Entergy Operations, Inc.  
7003 Bald Hill Road  
P.O. Box 756  
Port Gibson, MS 39150  
Tel 601 437 6694

GNRO-2008/00061

**SUBJECT:** Supplement 2 to Amendment Request  
Changes to Technical Specification 5.6.5, "Core Operating Limits  
Report (COLR)"  
Grand Gulf Nuclear Station, Unit 1  
Docket No. 50-416  
License No. NPF-29

RESPONSE TO REQUEST FOR ADDITIONAL INFORMATION  
REGARDING LICENSE AMENDMENT REQUEST:  
CHANGES TO TECHNICAL SPECIFICATIONS 5.6.5,  
CORE OPERATING LIMITS REPORT (COLR)

Figure 1. GGNS C17 E1A Stability Regions

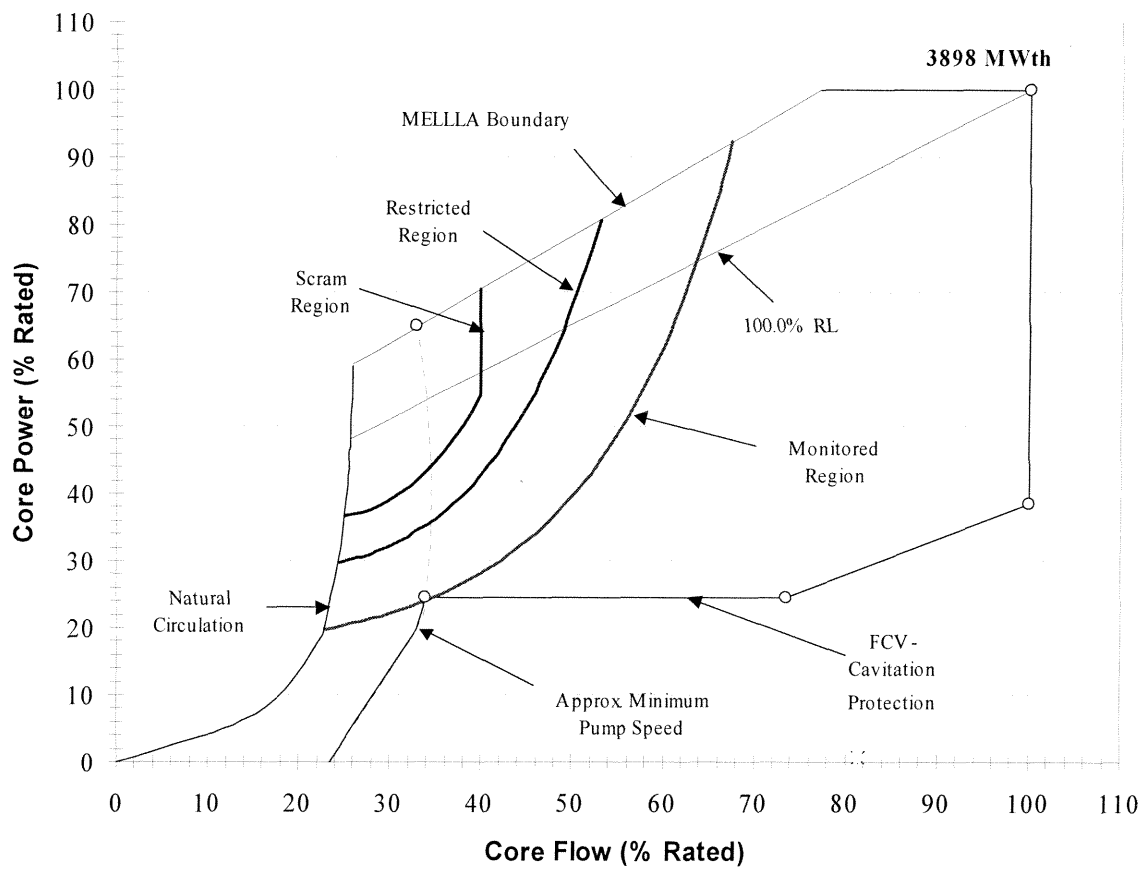
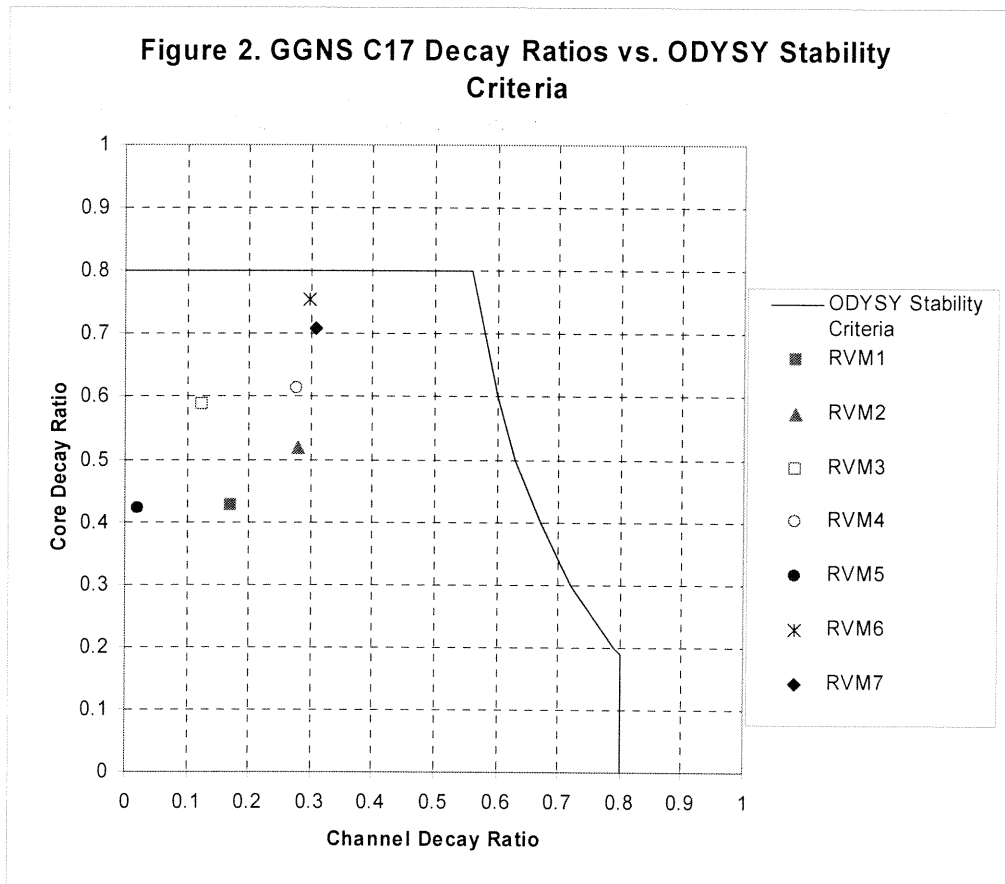
Note 1: Stability regions = A figure showing the stability regions, like Figures 4-4 and 4-5 of the Core Operating Limits Report (COLR) submitted by letter dated March 23, 2004 (GNRO-2004/00022).

Below are the decay ratios resulting from ODYSY analysis for Grand Gulf Cycle 17. Figure 1 shows the stability regions. Figure 2 provides a comparison of the result values to the Acceptance Criteria.

Case	State	Cycle 17	
		Core Decay Ratio	Channel Decay Ratio
RVM1	B	0.427	0.172
RVM2	A'	0.520	0.280
RVM3	B'	0.587	0.124
RVM4	FRE H1	0.615	0.276
RVM5	FRE H0	0.422	0.021
RVM6	A' LOFH	0.754	0.297
RVM7	B' LOFH	0.709	0.307
